COLLIN COUNTY, TEXAS

ADDENDUM No. One (1)

IFB NO. 2014-341

**Construction, Myers Park Pavilion**

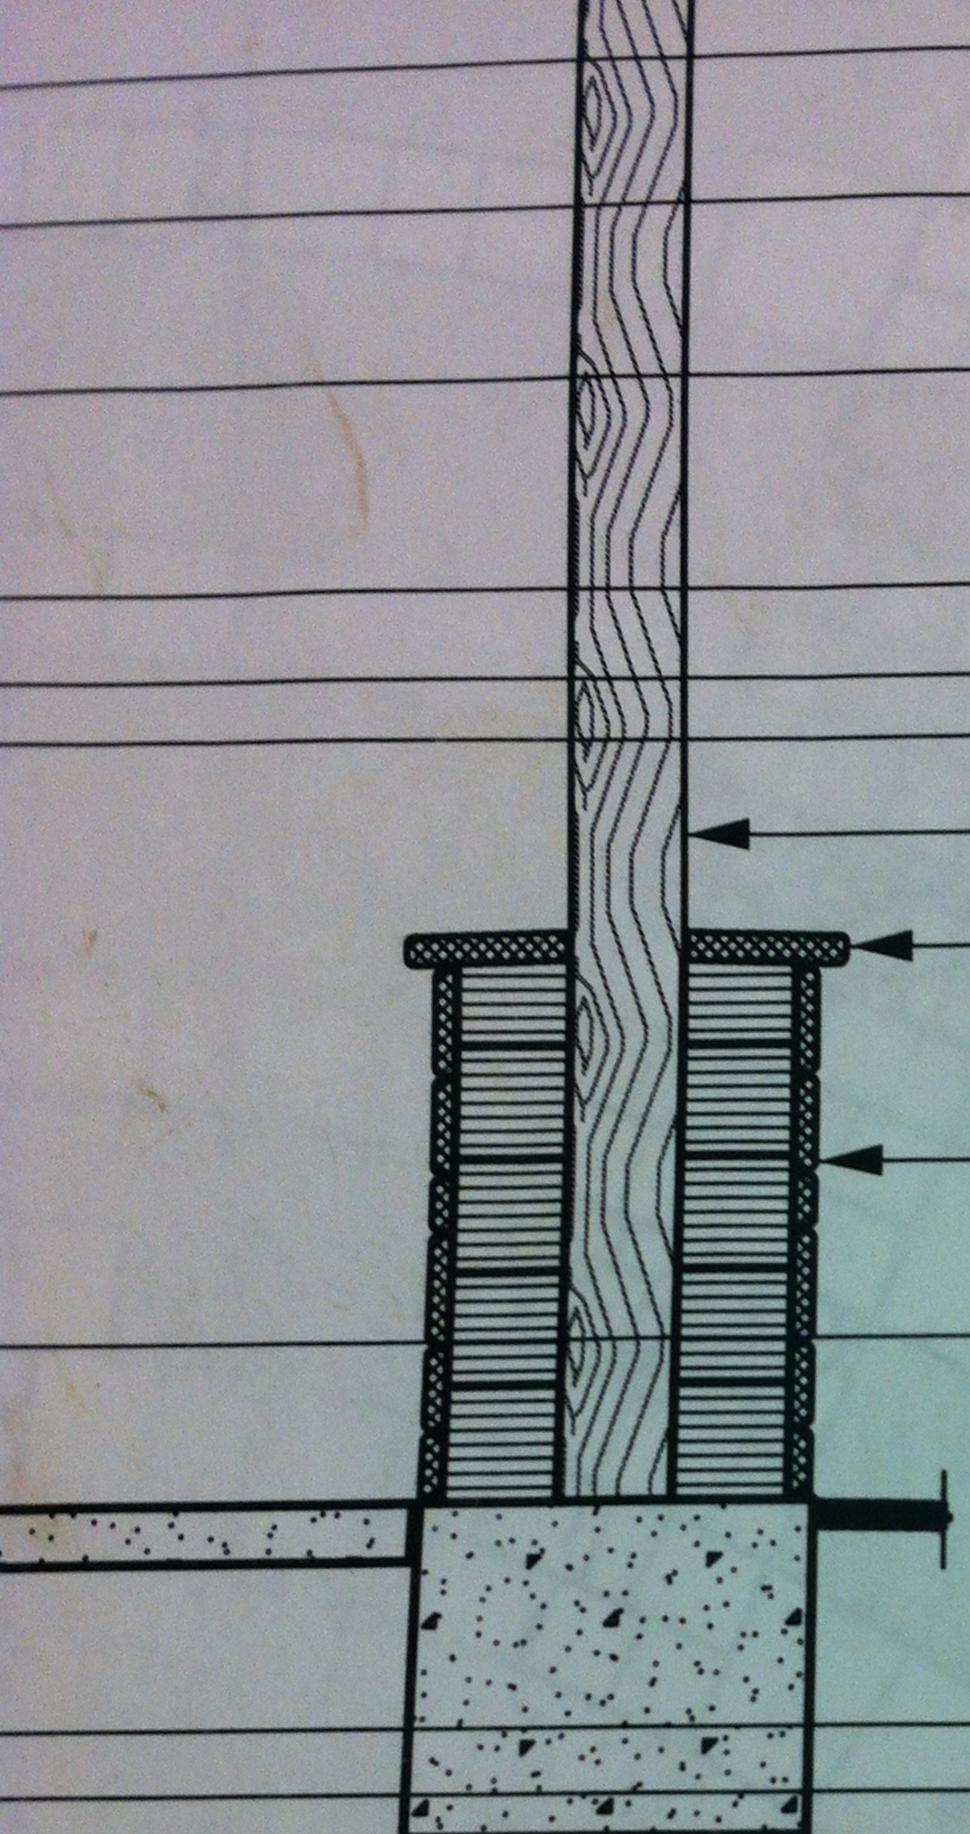
ADD: Manufactured Stone Masonry Specification and Detail  
ADD: Mandatory Pre-Bid Sign-in Sheets

SIM. STONE ON MORTAR BED  
 OVER METAL LATH (04 73 00)  
 OVER 8" STD. CMU (04 22 00)  
 W/FOAMED-IN PLACE INSULATION  
 (07 13 00) TYP ● EXT. CMU

SIM. STONE WATERTABLE (04 73 00)  
 CAULK ● CEDAR POSTS, TYP.

SIM. STONE ON MORTAR BED  
 OVER METAL LATH (04 73 00)  
 OVER 8" STD. CMU (04 22 00)
